# City of Albuquerque

RE: ENGINEER CERTIFICATION FOR COACHMAN ESTATES (E22-D3D) CERTIFICATION  
STATEMENT DATED 3/25/93.

RE: DRAINAGE REPORT FOR COACHMAN ESTATES (E22/D3D)  
ENGINEER'S STAMP DATED AUGUST 31, 1992

**DRAINAGE REPORT**  
**FOR**  
**Coachman Estates Subdivision**

TITLE: COACHMAN ESTATES SUBDIVISION  
GRADING PLAN

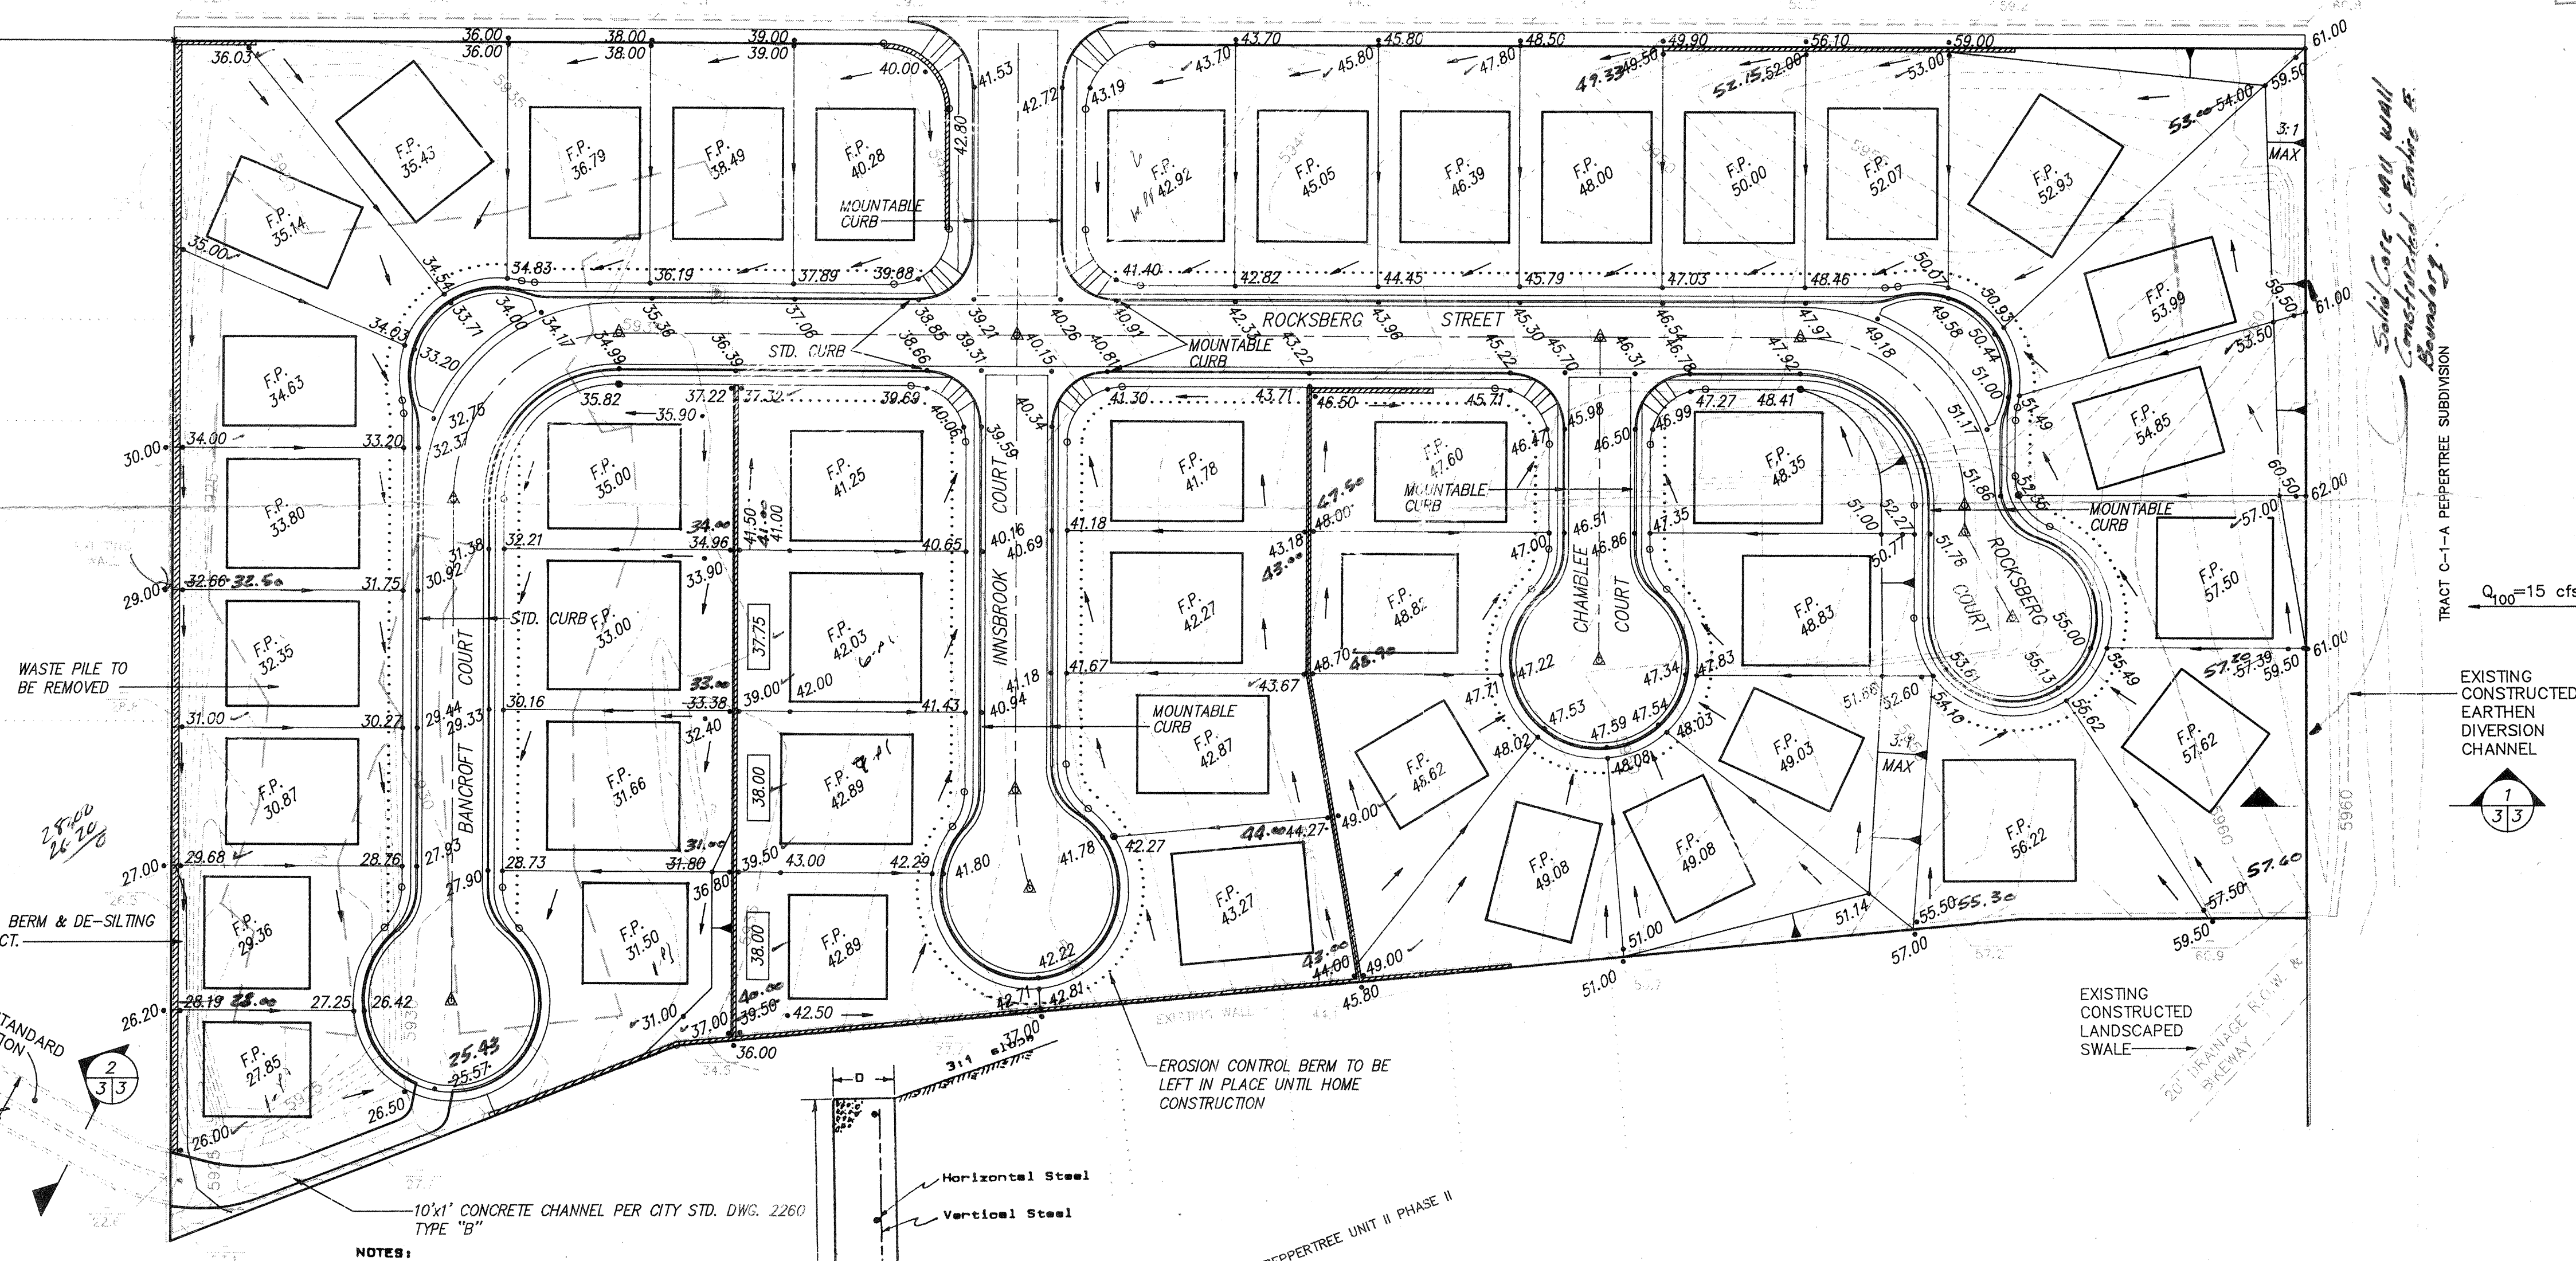
Please be advised that our office has received numerous calls of the excess  
fill dirt placed against the existing wall on the west property line at the  
above referenced site.

Certification will not be accepted until a revised plan has been submitted for  
review which will address a retaining wall at the location where the fill dirt  
has been placed.

Also, on the far southwest corner lot, up against the 10'x1' concrete channel,  
your plan indicates a change of grade of 3.6' feet? Please address how the  
change of grade will be compensated for.

I hereby certify that the information contained on this drawing has been revised in accordance with information furnished by the Contractor, Universal Constructors, Inc., and by the Surveyor, D. Mark Goodwin and Associates, and reflects the construction as actually accomplished. This plan as constructed is in compliance with the Approved Plan, with particular emphasis on the retaining wall locations and height, and earthwork grading.
